CITY OF ALBUQUERQUE

**Planning Department
Transportation Development Services Section**

Re: Certification Submittal for Final Building Certificate of Occupancy for
Atrisco Business Park, Big Lots, [J-10 / D32]
465 Coors Blvd NW
Engineer's Stamp Dated 08/17/05

**Re: Tract F-6-A-1, Atrisco Business Park, Unit 3 – Grading & Drainage Plan
Engineer's Stamp dated 5-3-05 (J10-D32)**

DETAIL CONNECTION "A"

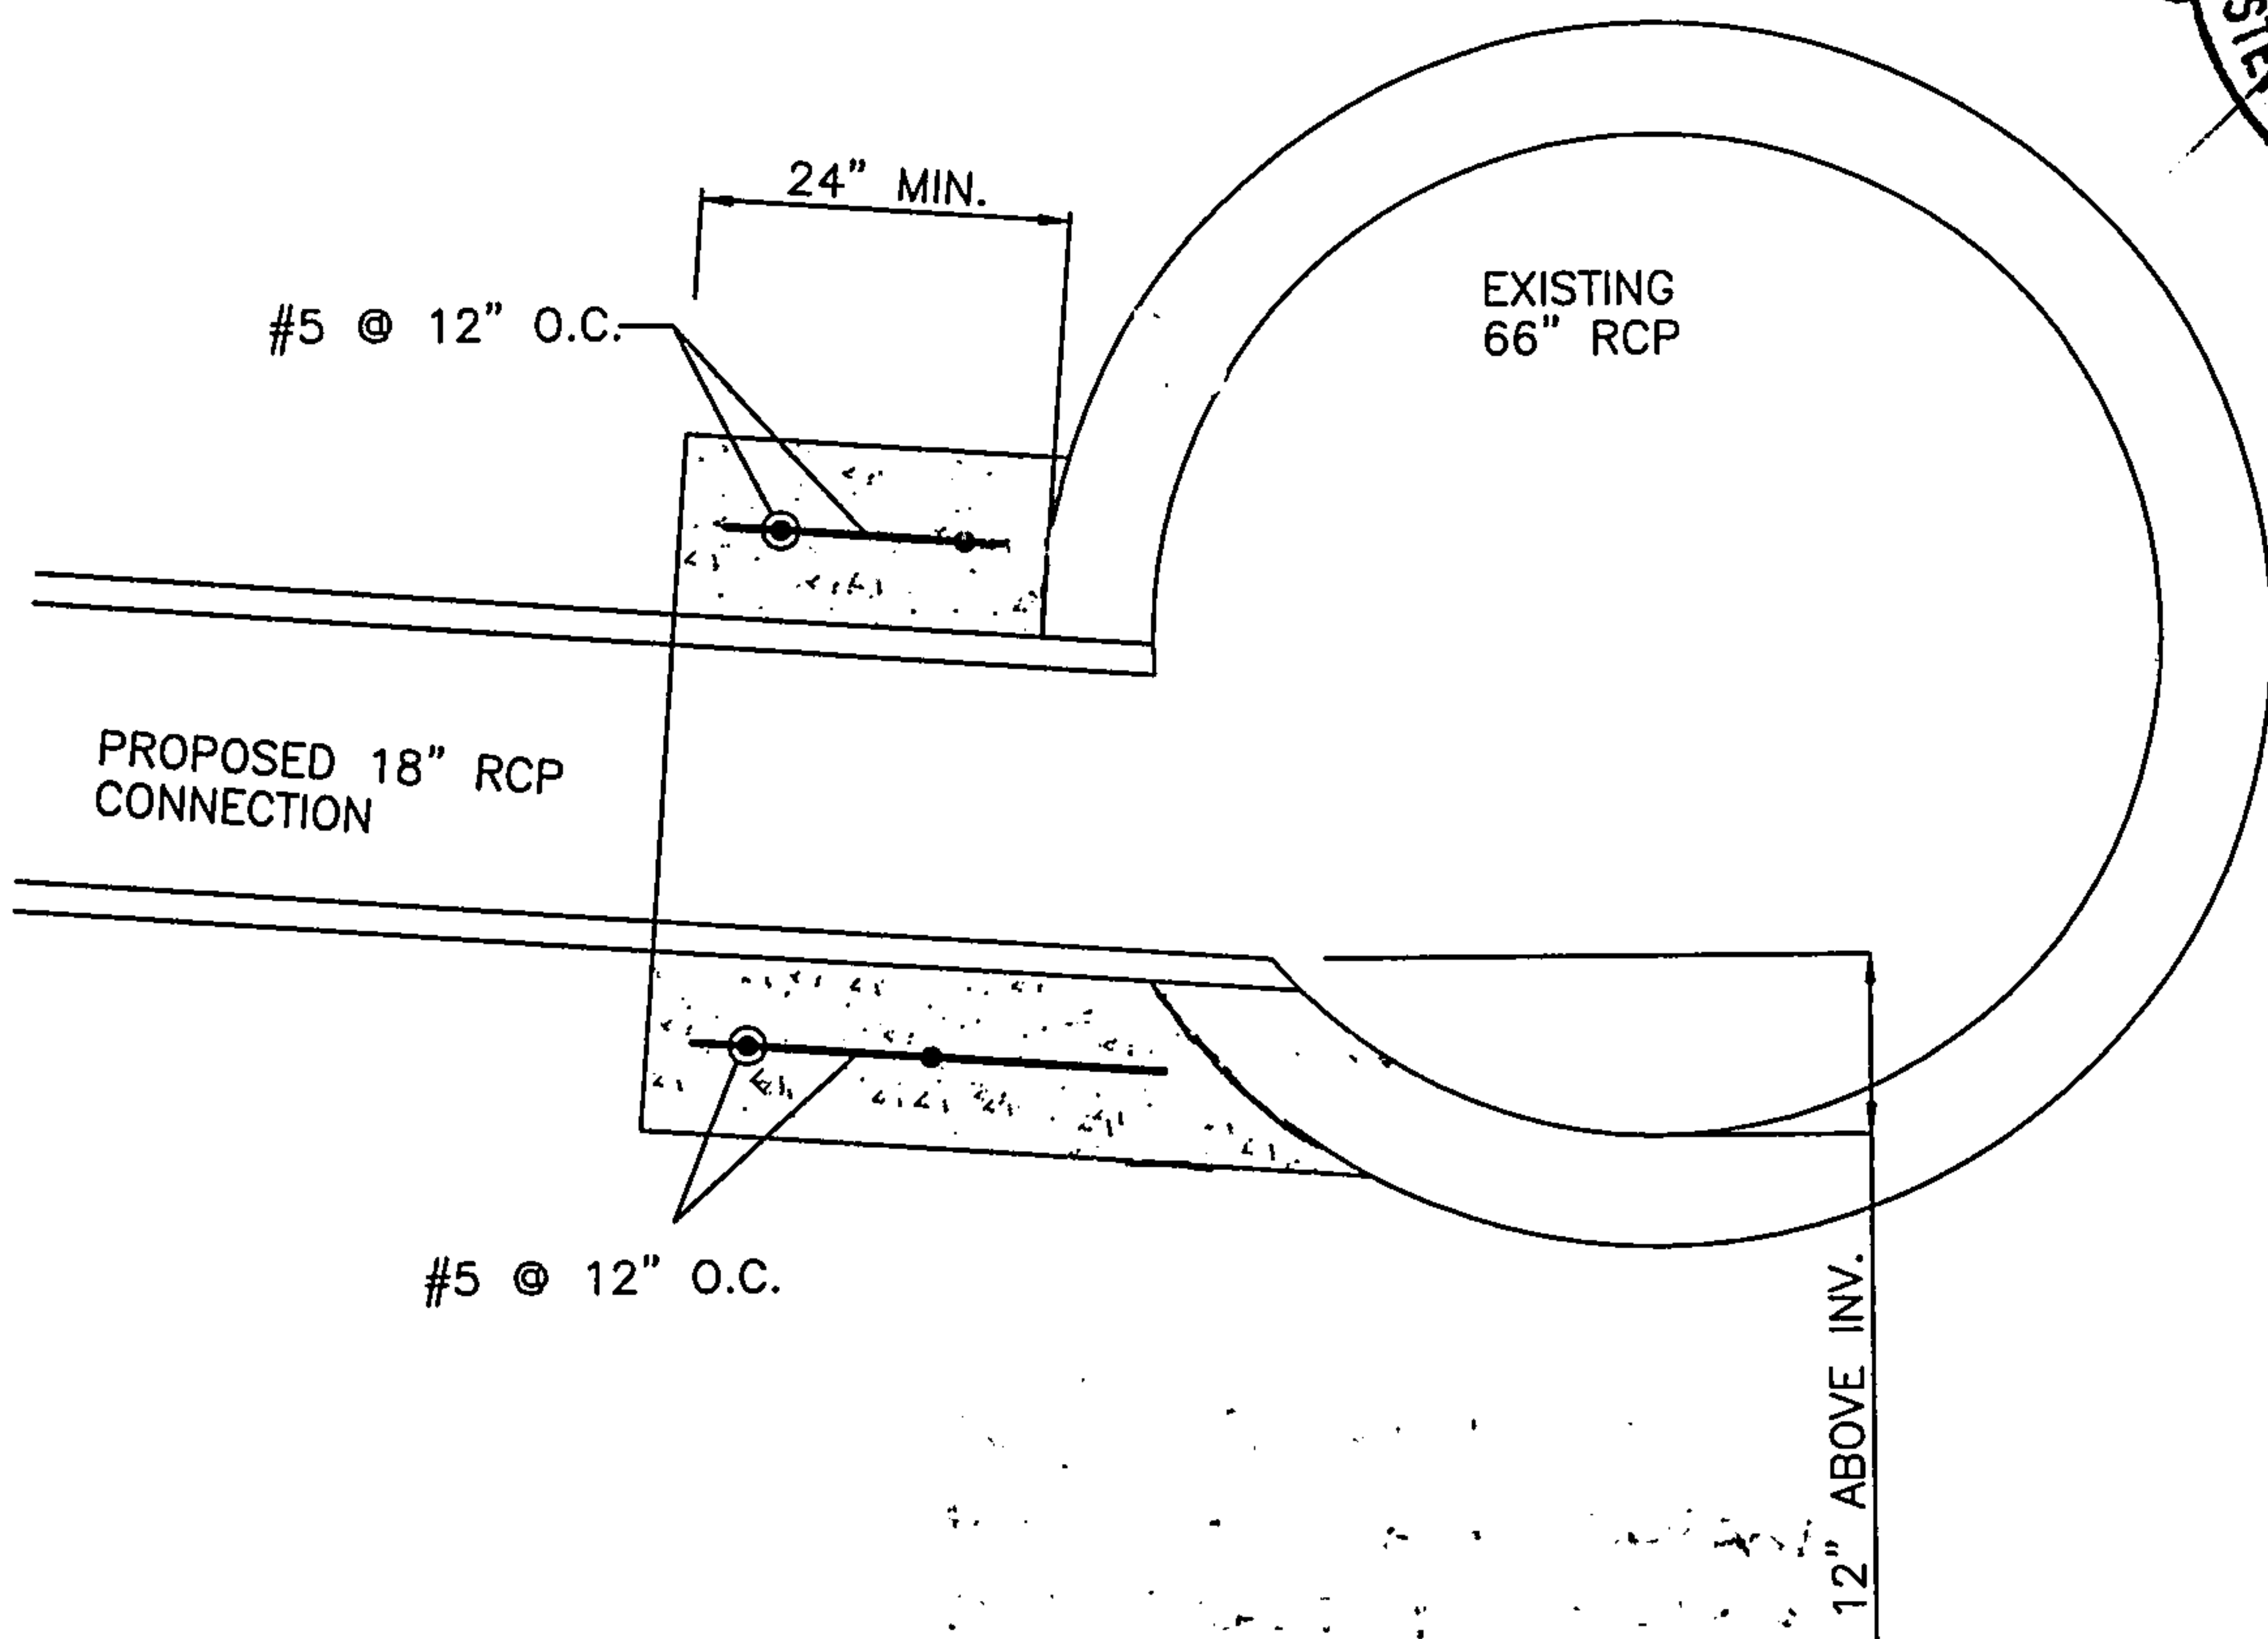
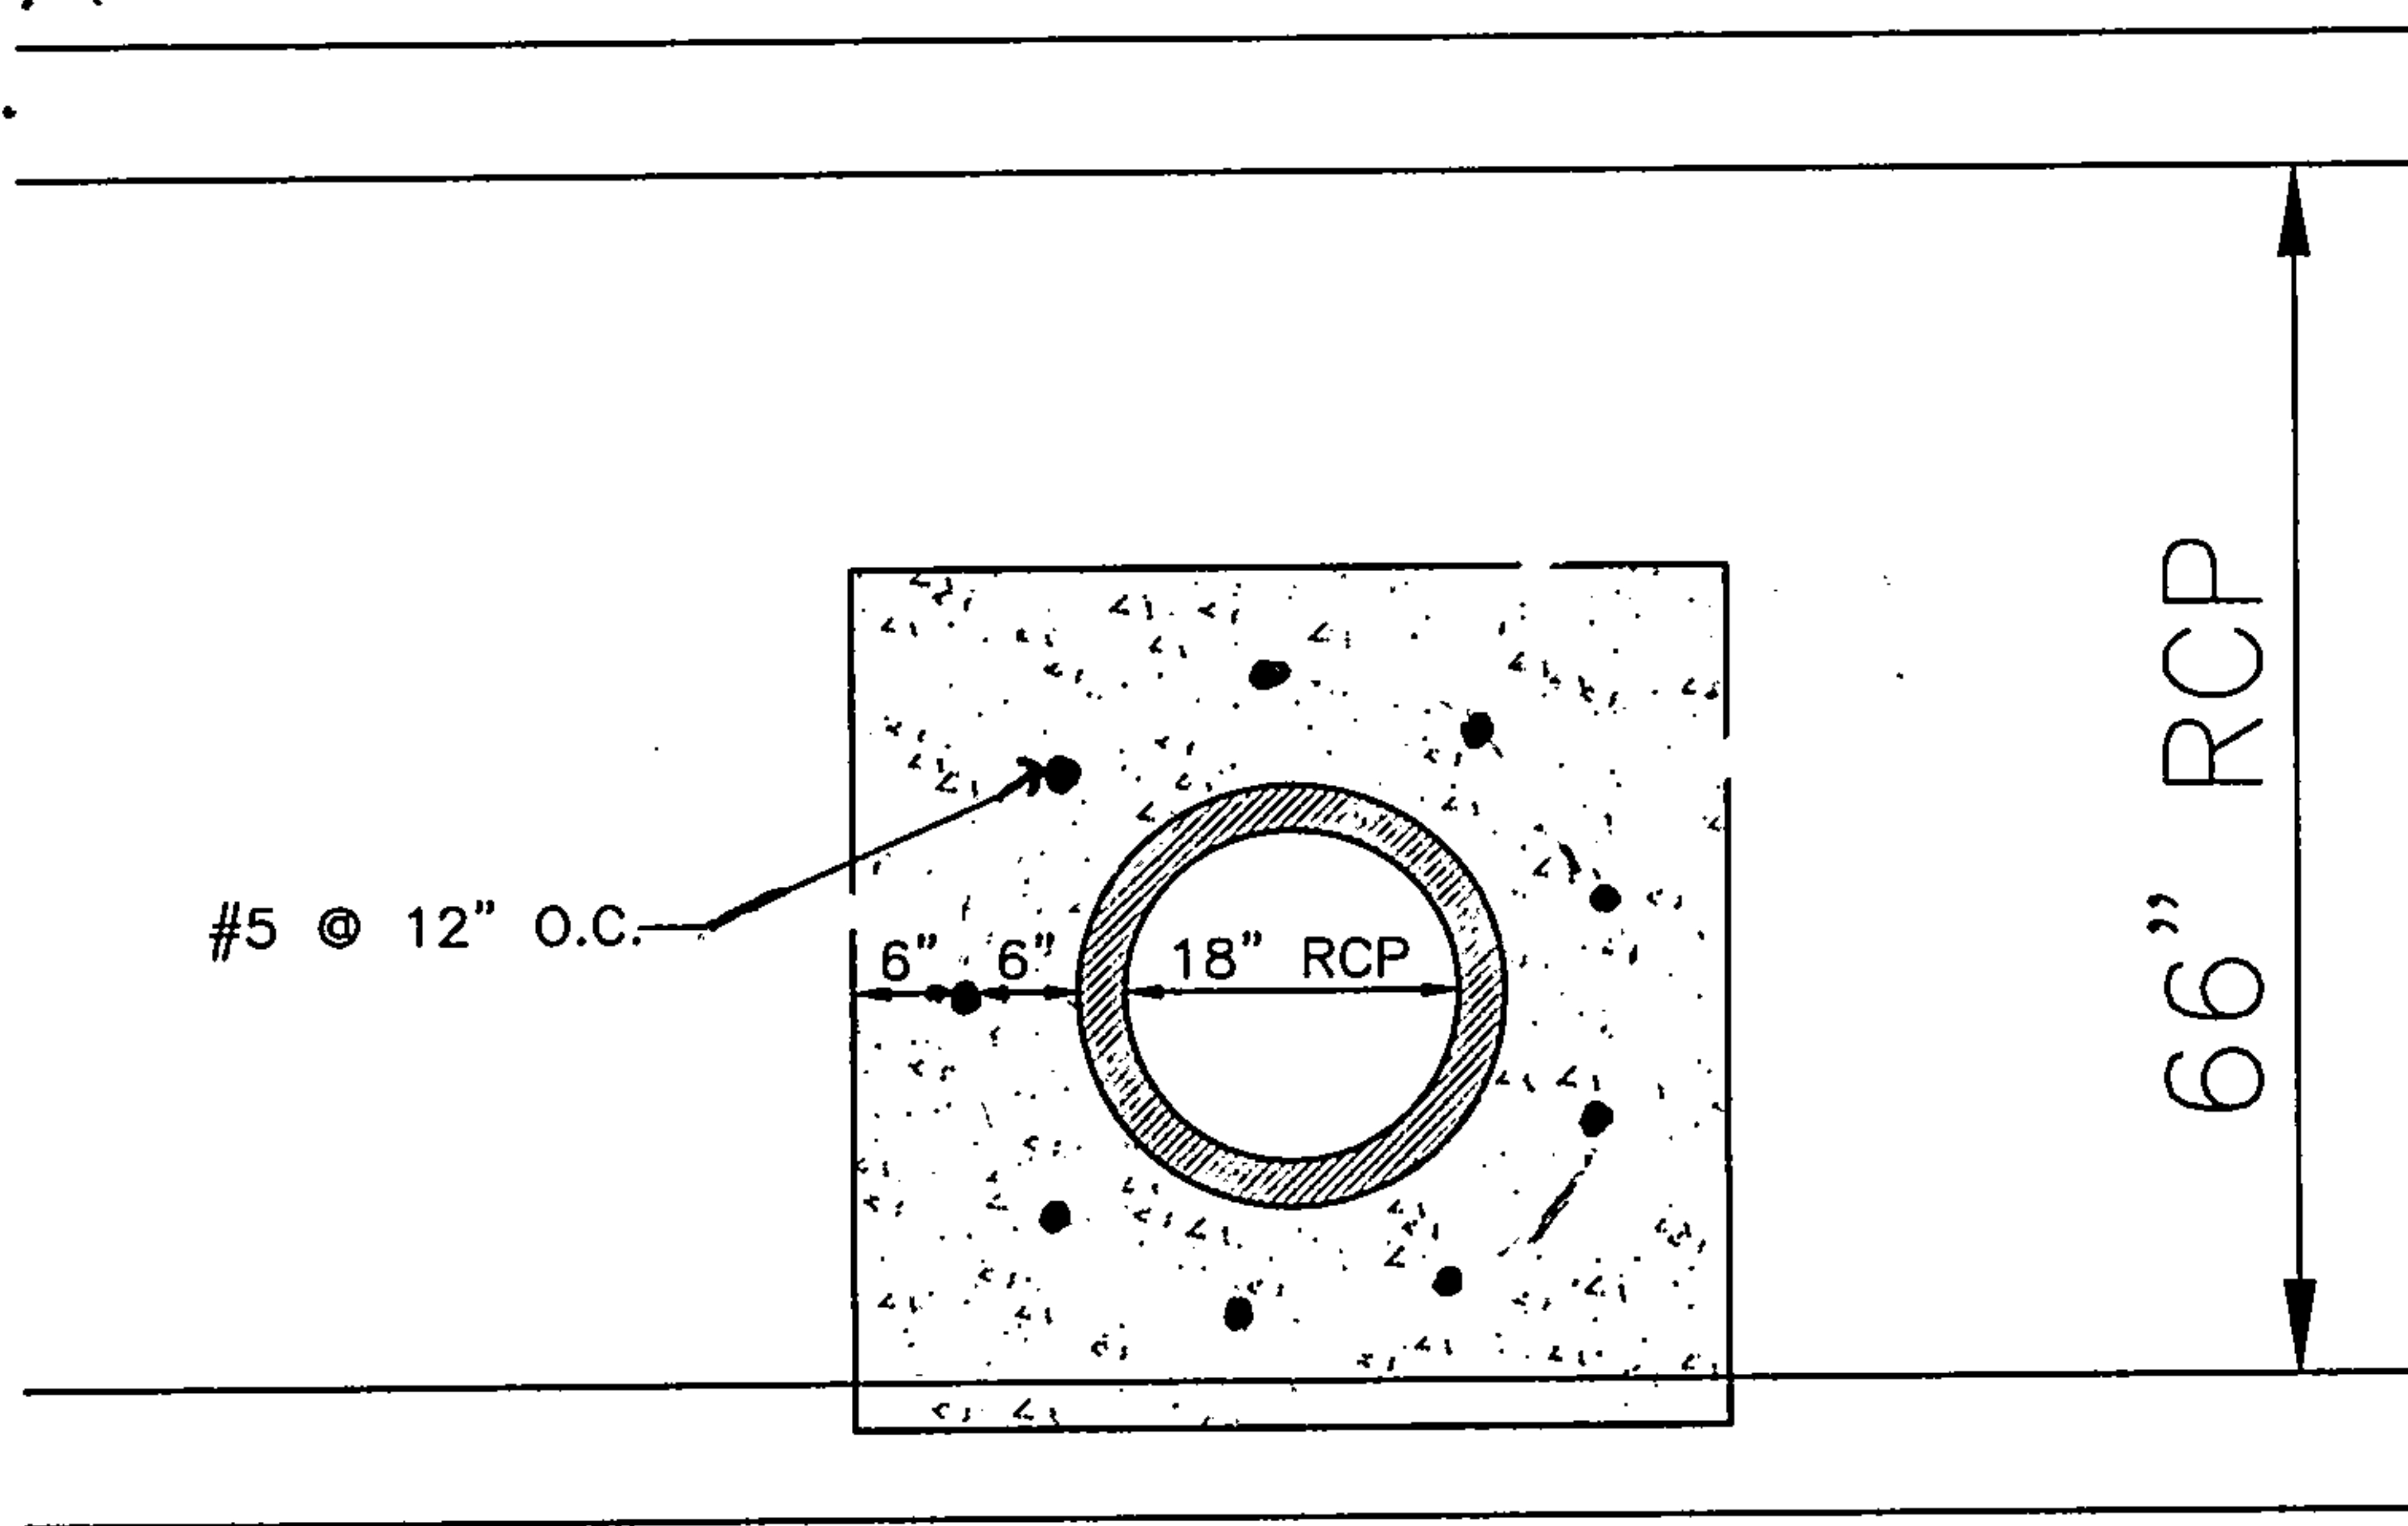
- Show detail for connection to existing storm drain on plan.
- Provide addresses for both sites connecting to existing storm drain.

DETAIL CONNECTION "B"
